SUNDRY NOTICES AND REPORTS ON WELLS

Nearburg Producing Company 30-025-34317 Gazelle 31 Federal 1 Conditions of Approval

Permanent Abandonment of Production Zone Conditions of Approval

PROPOSED WELLBORE DIAGRAM

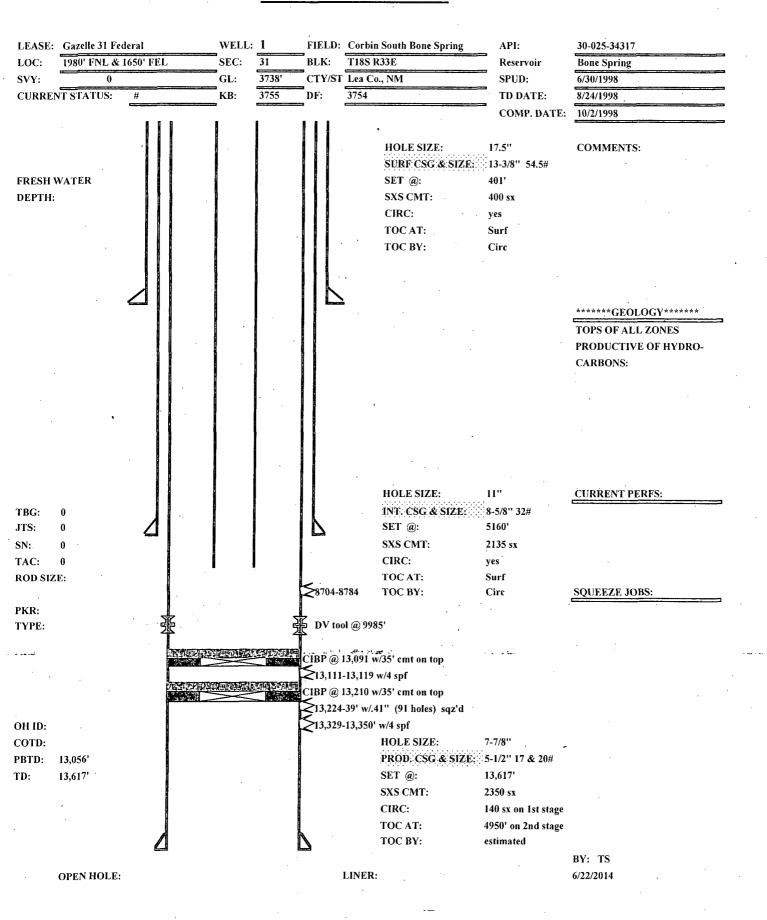
- 1. Operator shall set a CIBP at 13,061' and dump 35' of cement on top.
- 2. Operator shall set a class H cement plug from 10,654'-10,444'. (Top of Wolfcamp 10,614')

- 3. Operator shall set a class H cement plug from 10,035'-9,835'. WOC and Tag. (DV Tool 9985')
- 4. Must conduct a casing integrity test before perforating and fracturing. Submit results to BLM. The CIT is to be performed on the production casing to 1500 psi. Notify BLM if test fails.
